PROJECT NAME:  
**5B OVERTON GARDENS,  
COTTESLOE**

**NO. 5B OVERTON GARDENS, COTTESLOE - PROPOSED THREE STOREY SINGLE HOUSE**

This letter has been prepared to assist the Town in the preparation of its report to Council on 28 June 2016 for the proposed construction of a three storey development at No. 5B Overton Gardens, Cottesloe.

**10.1.3 NO. 5B (LOT 42) OVERTON GARDENS – THREE-STOREY DWELLING**

**Fig. 1:** Side elevation demonstrating the line of sight from the footpath – note that third storey is not visible due to its proposed setback and the projection of the second storey roof feature. The human scale of the building is appropriate.

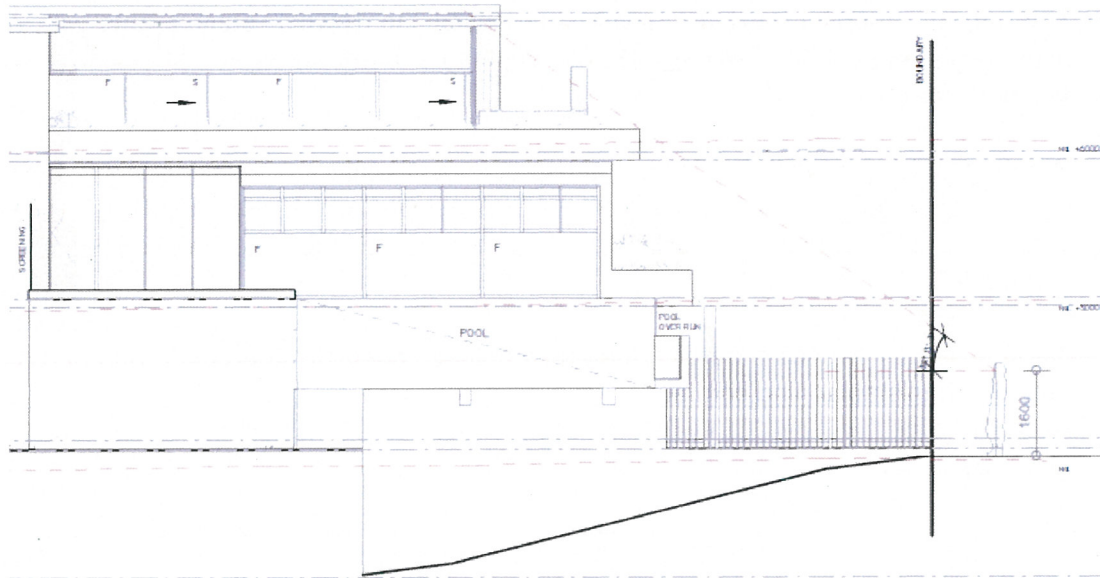
Generally, the accepted planning test in regards to maintaining an appropriate level of building bulk and scale and respect for streetscape and amenity is the presentation of the building from the perspective of the human scale. Figure 1 explains the human scale of the proposed development from the perspective of a pedestrian standing on the footpath in front of the property. The image is able to demonstrate that the third storey will not be visible from this location and that the design of the building is appropriate in terms of human scale.

The second storey has been setback to 6m from the Overton Gardens boundary whilst the third storey is setback an additional 2.5 metres behind the floor to achieve an 8.5m setback. Despite the potential for the development to be approved with a 2m setback under the R-Codes, it was important for our client to ensure that the views and amenity of neighbours was respected.

The 3D perspective below illustrates the relationship between the subject site and adjoining properties in support of the third storey proposal as submitted.
